HIGHWAY CONSTRUCTION BID PLANS OF PROPOSED ^{FINAL} FEDERAL AID PROJECT NO. IM-0703-322 STATE HIGHWAY NO. 70 EISENHOWER/JOHNSON MEMORIAL TUNNEL PANEL REPLACEMENT PROJECT - *ESMT-South Tunnel* SUMMIT AND CLEAR CREEK COUNTIES CONSTRUCTION PROJECT CODE NO. 16102

EISENHOWER/JOHNSON MEMORIAL TUNNEL
 PANEL REPLACEMENT PROJECT
 SUMMARY OF APPROXIMATE FINAL
 QUANTITIES
 Designer: J. BRAAKSMA Structure F-13-X
 Detailer: J. SPANIER Numbers
 Sheet Subset: Subset Sheets: S-2 OF S-19

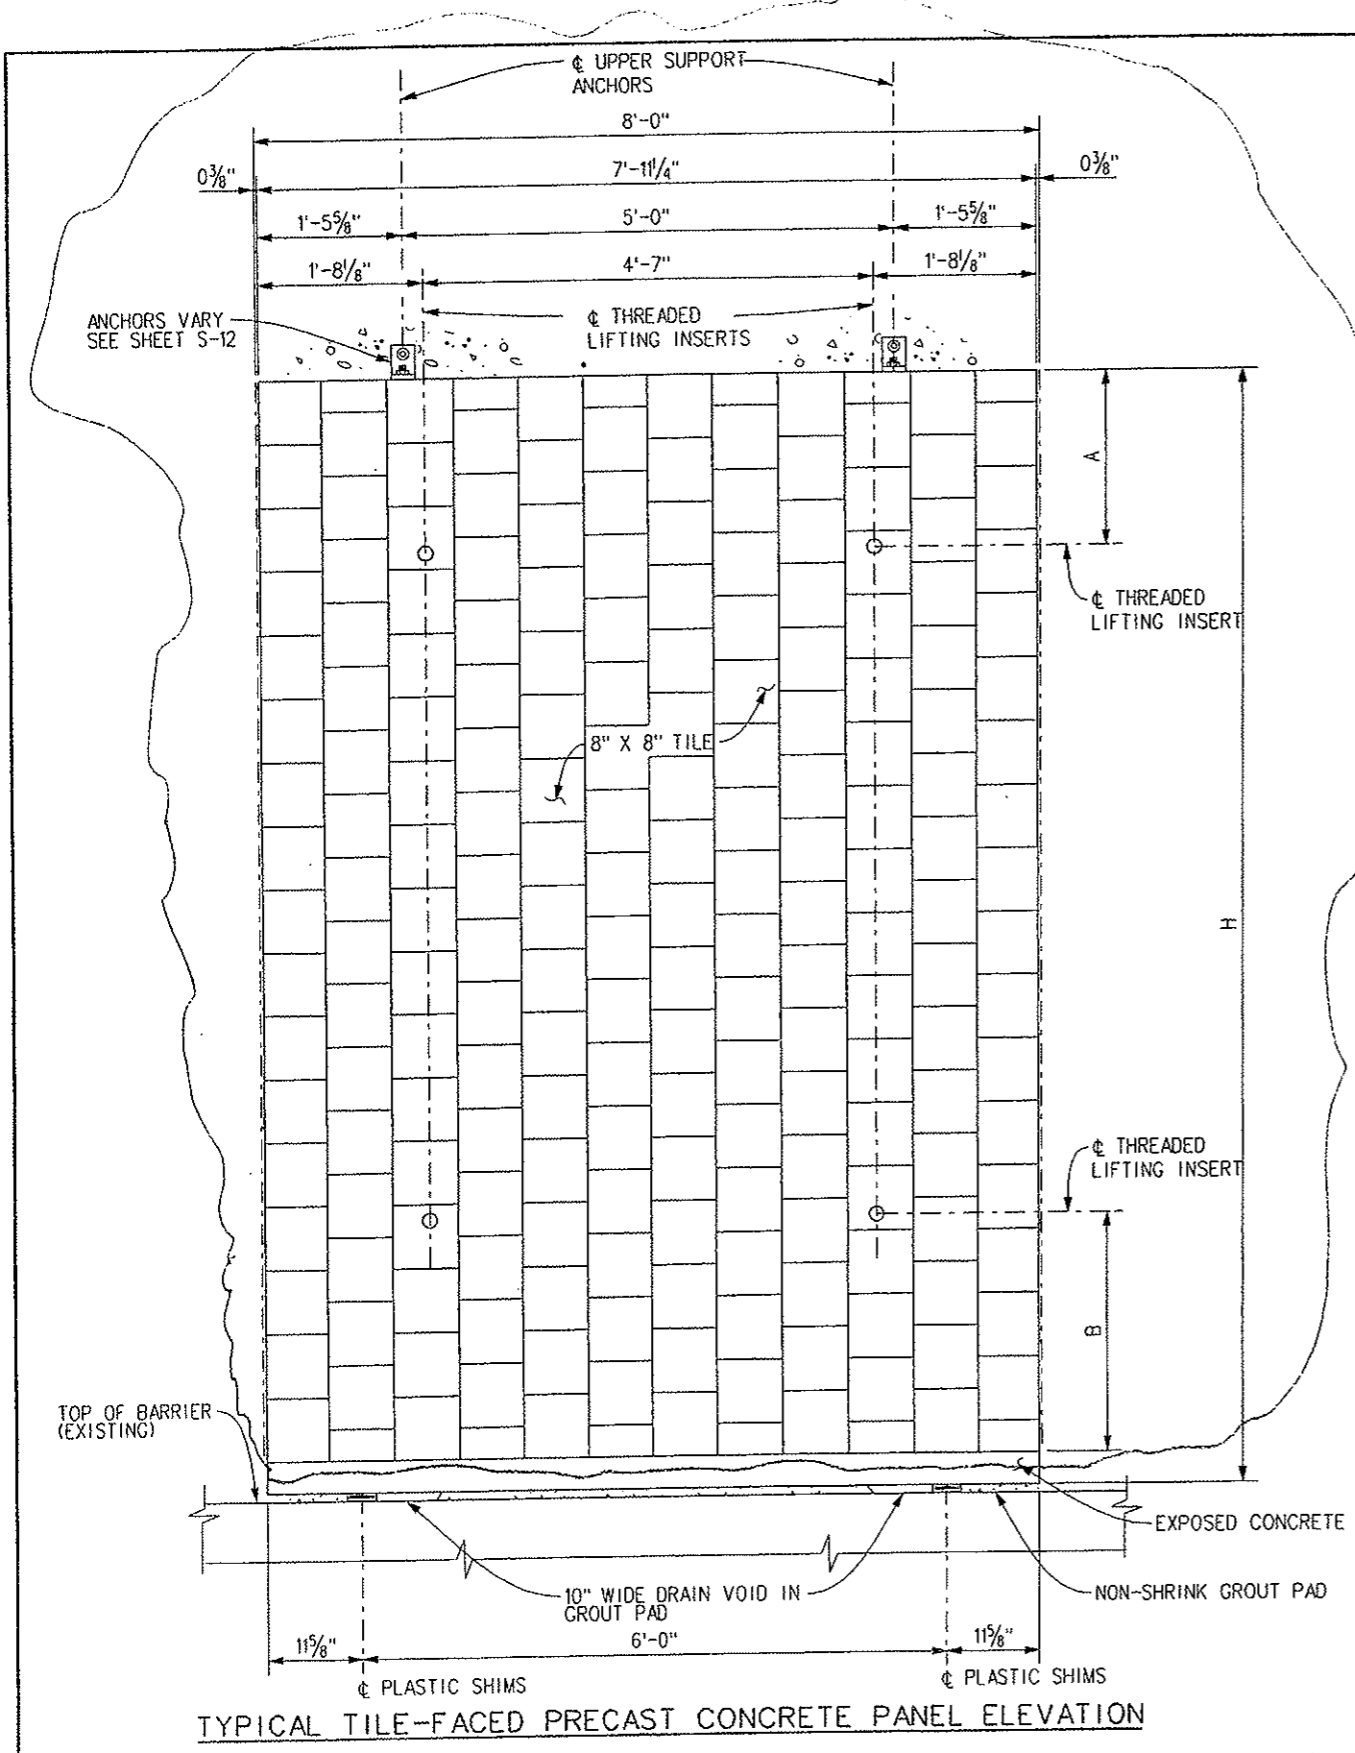
SEE SHEET 13A FOR ACCEPTED TYPICALS

TYPICAL TILE-FACED PRECAST CONCRETE PANEL ELEVATION

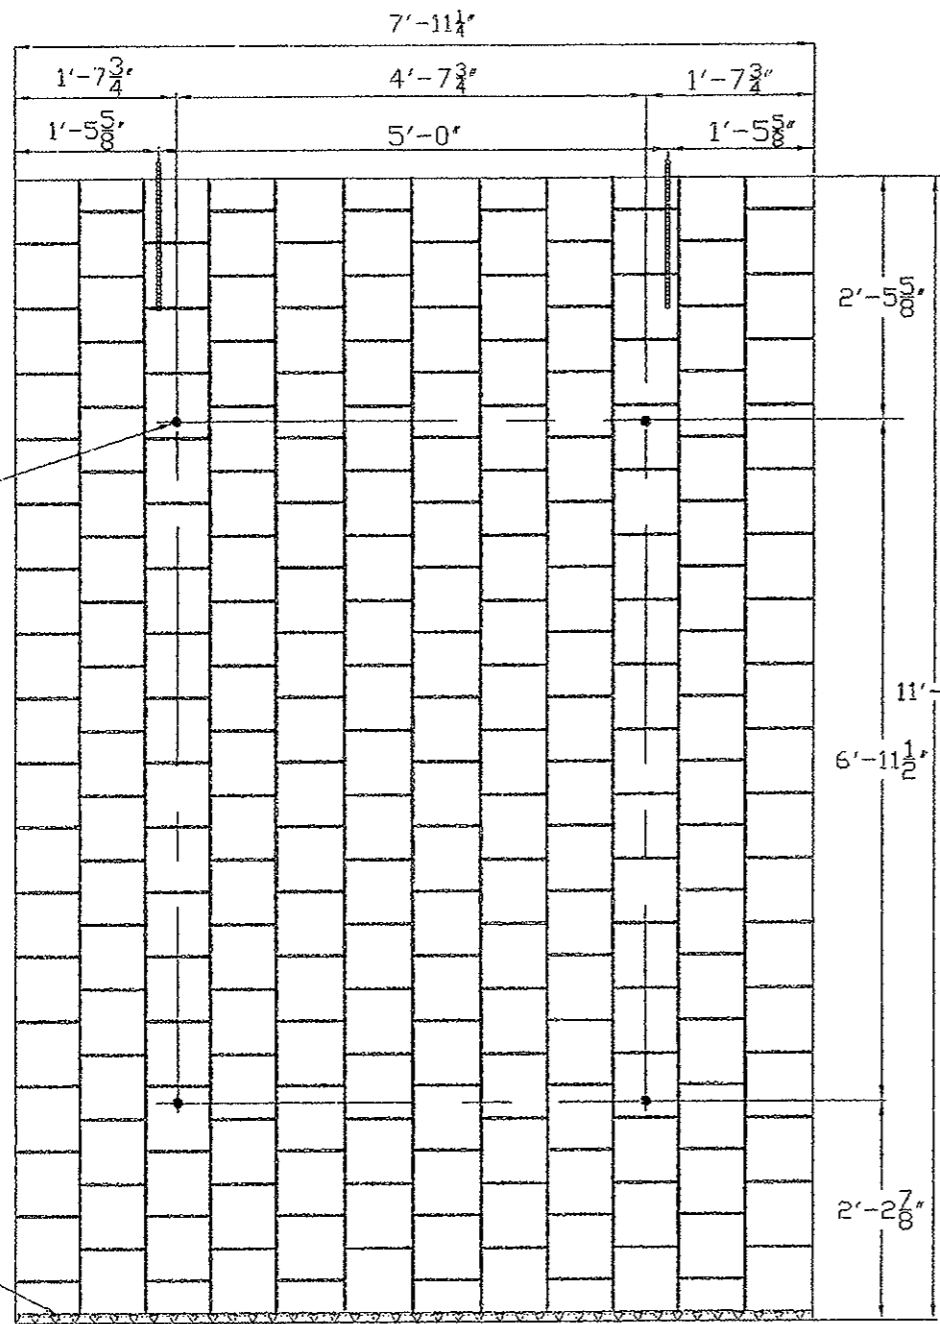
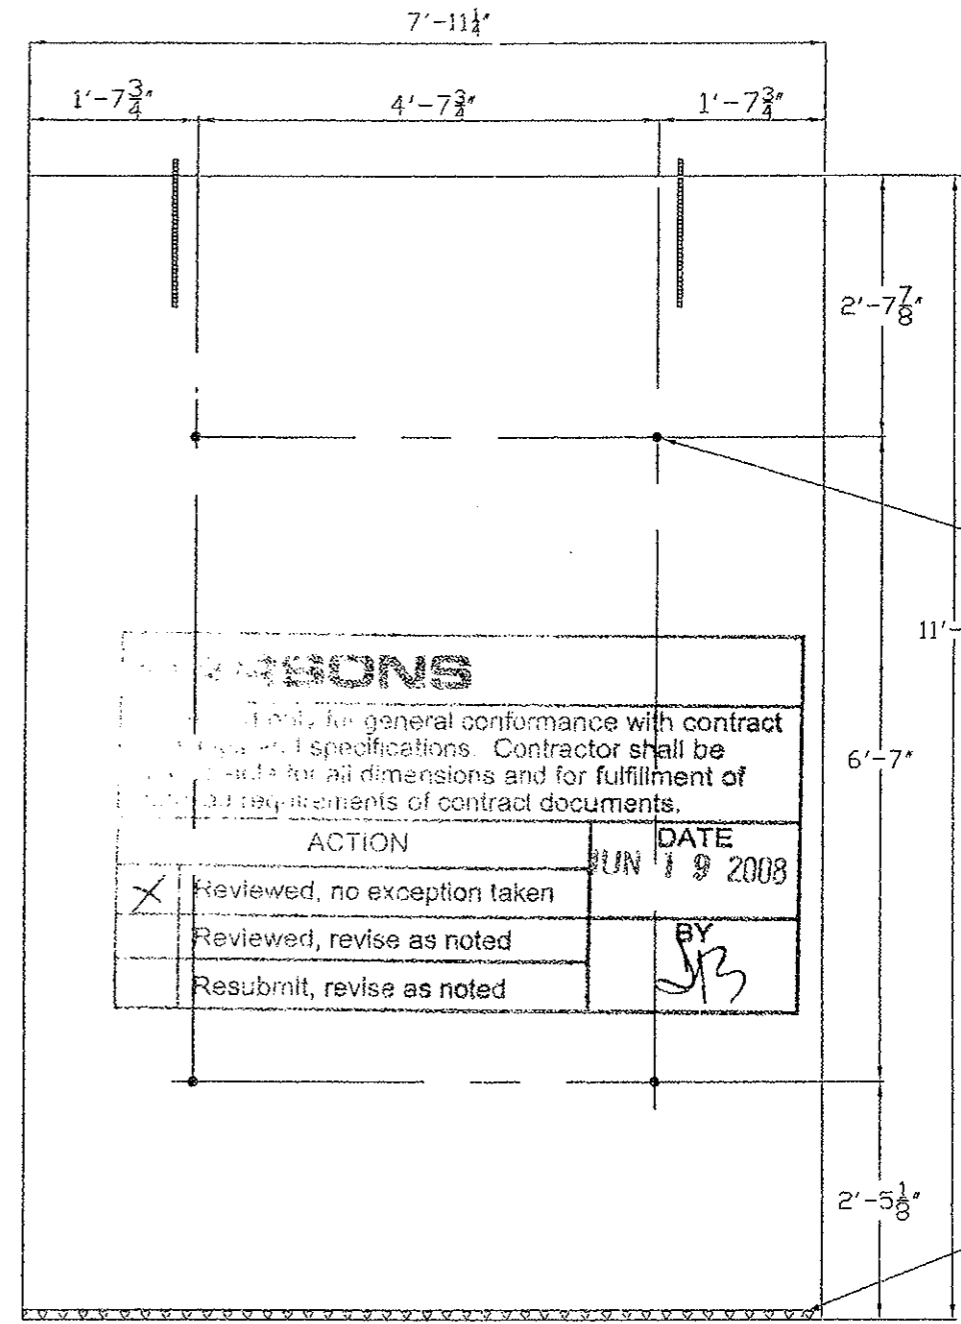
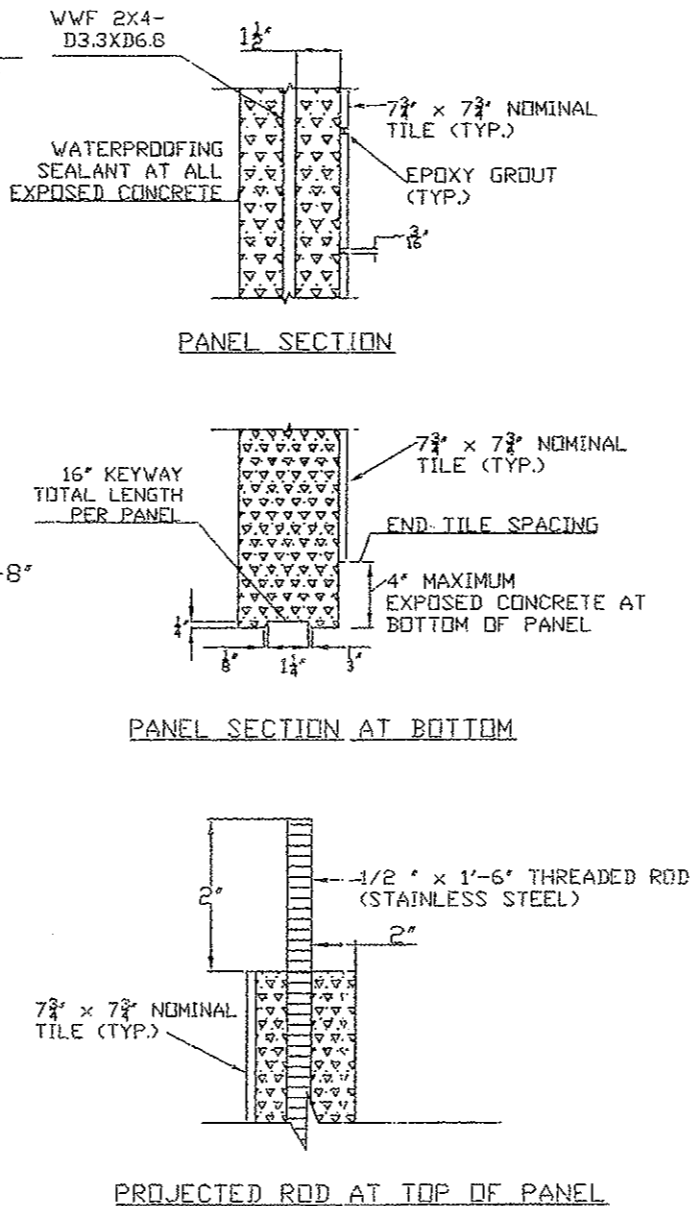
REVISIONS	
ACTION	DATE
Reviewed, no exception taken	JUN 19 2008
Reviewed, revise as noted	BY JCB
Resubmit, revise as noted

APPROVED
 As indicated
 JUN 0 2008
 [Signature]

DETAIL AT TOP CONNECTION (NORTH TUNNEL)

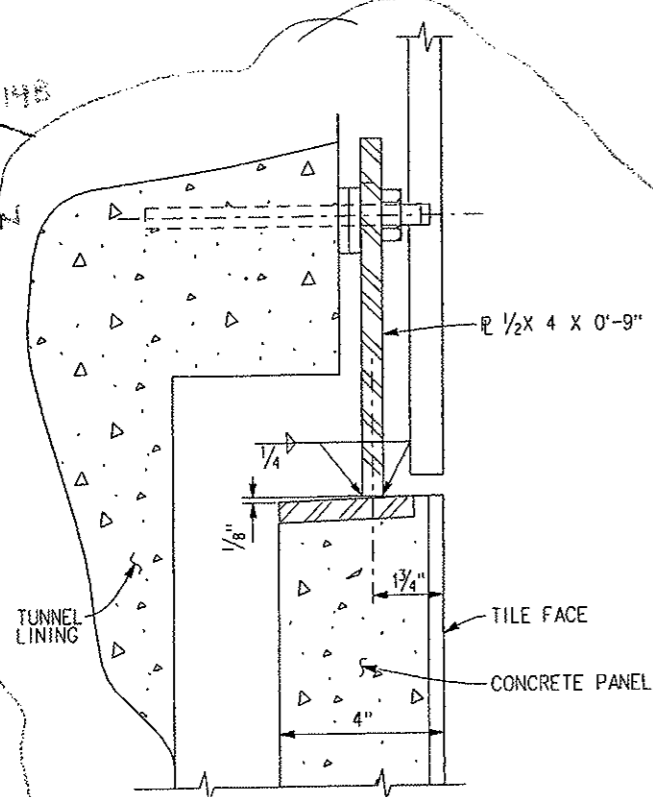
SEE PAGE 14B FOR ACCEPTED TOP CONNECTION

DETAIL AT TOP CONNECTION (SOUTH TUNNEL - INTERIOR ZONE)

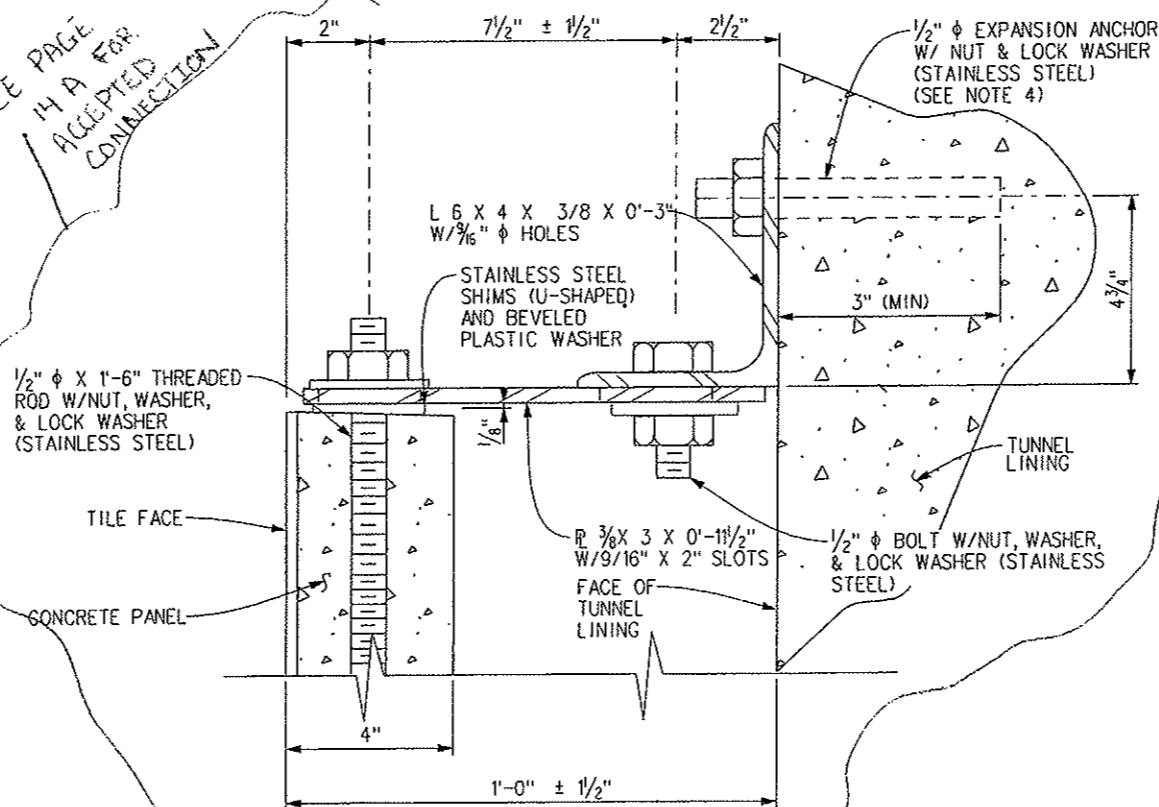
SEE PAGE 14A FOR ACCEPTED CONNECTION

DETAIL AT CONCRETE BLOCK WALLS (PORTAL AND TRANSITION AREAS)

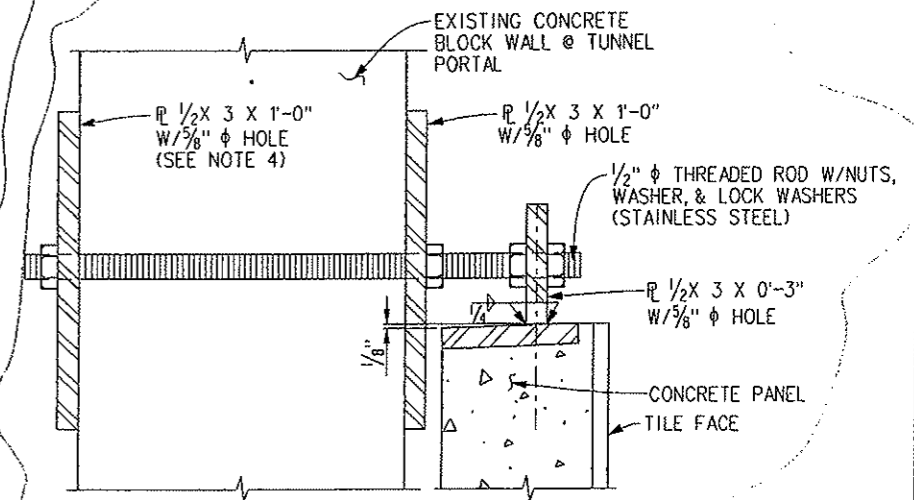
SEE PAGE 14C FOR ACCEPTED DETAIL

DETAIL AT PANEL BOTTOM (SEE NOTE 5)

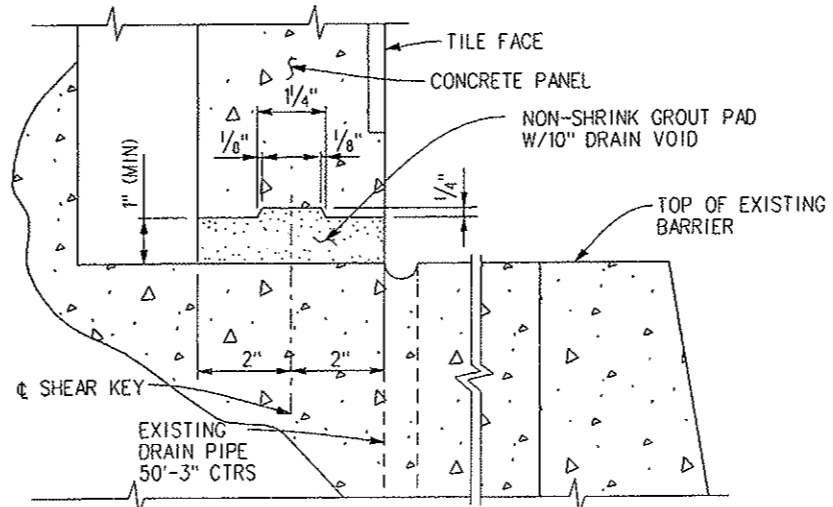
SEE PAGE 14B FOR ACCEPTED PLATE

standard Top connection Detail
NOTE: ALL MILD STEEL TO BE GALVANIZED TYP.

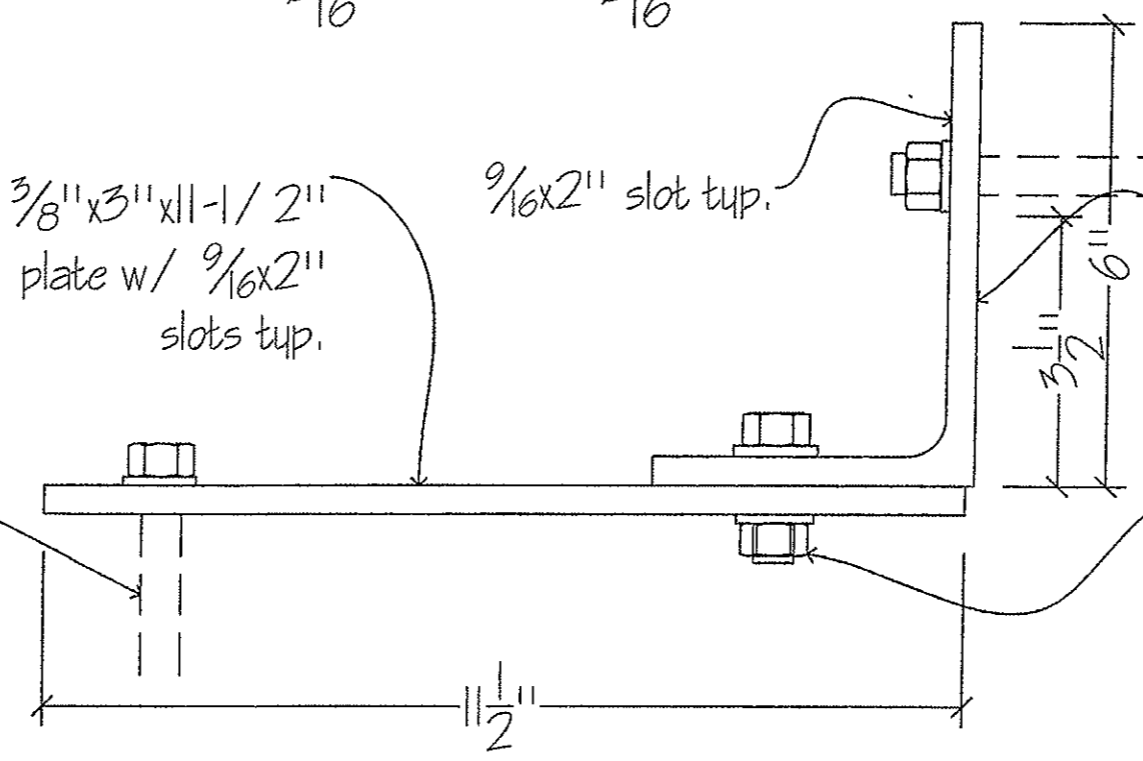
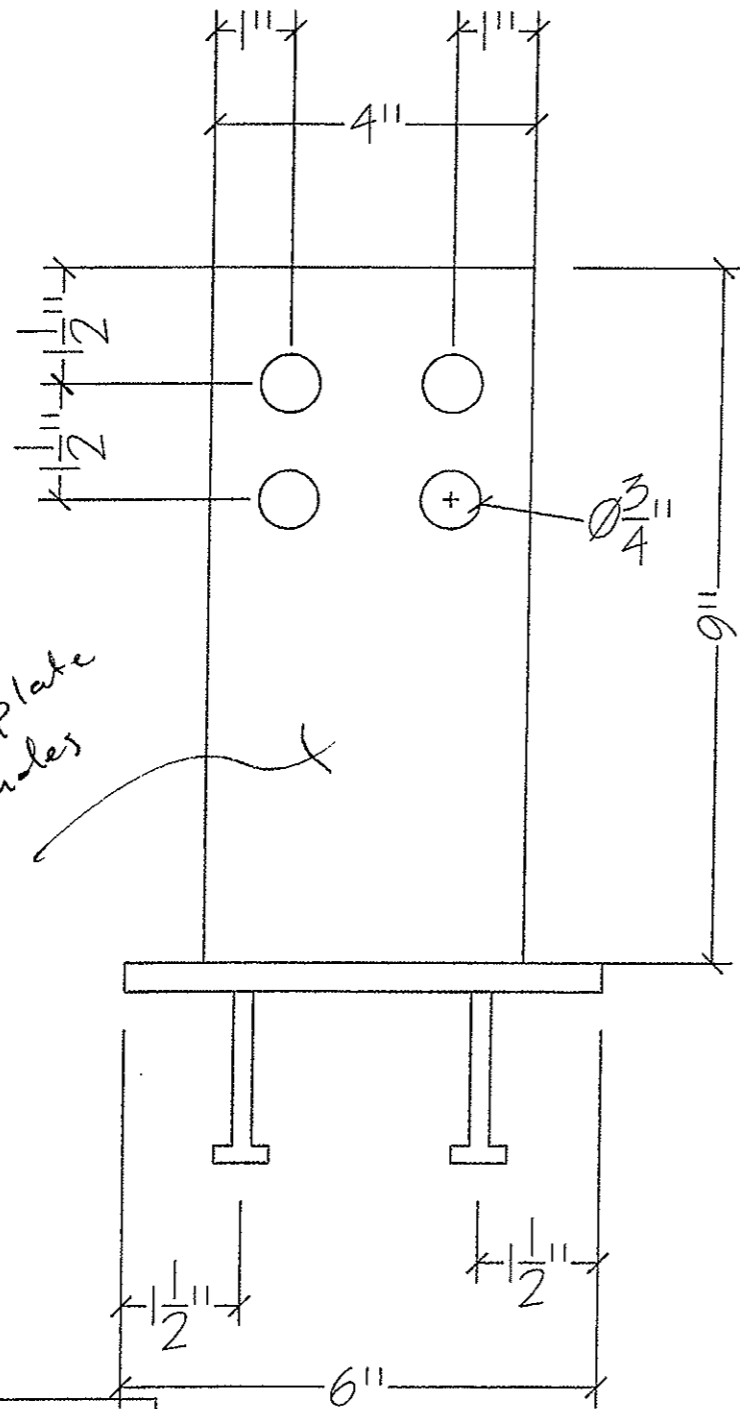
PARSONS Reviewed only for general conformance with contract drawings and specifications. Contractor shall be responsible for all dimensions and for fulfillment of detailed requirements of contract documents.	ACTION	DATE
	Reviewed, no exception taken	JUN 19 2008
	Reviewed, revise as noted	BY: <i>JLS</i>

APPROVED
for construction
JUN 04 2008
BY: *Donald Hambl*
Flatiron

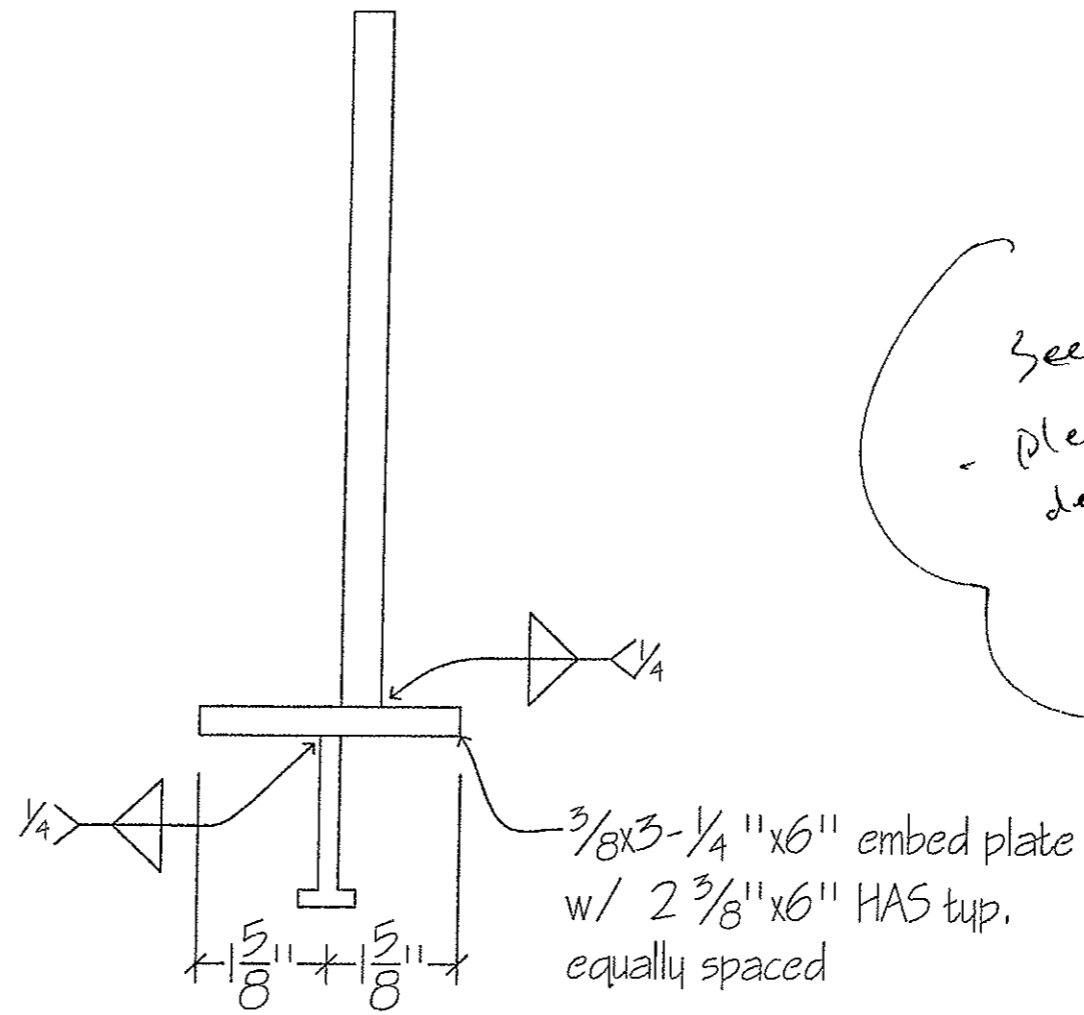
See plansheet 14, note 3
- Please provide embed plate
design color for
project records
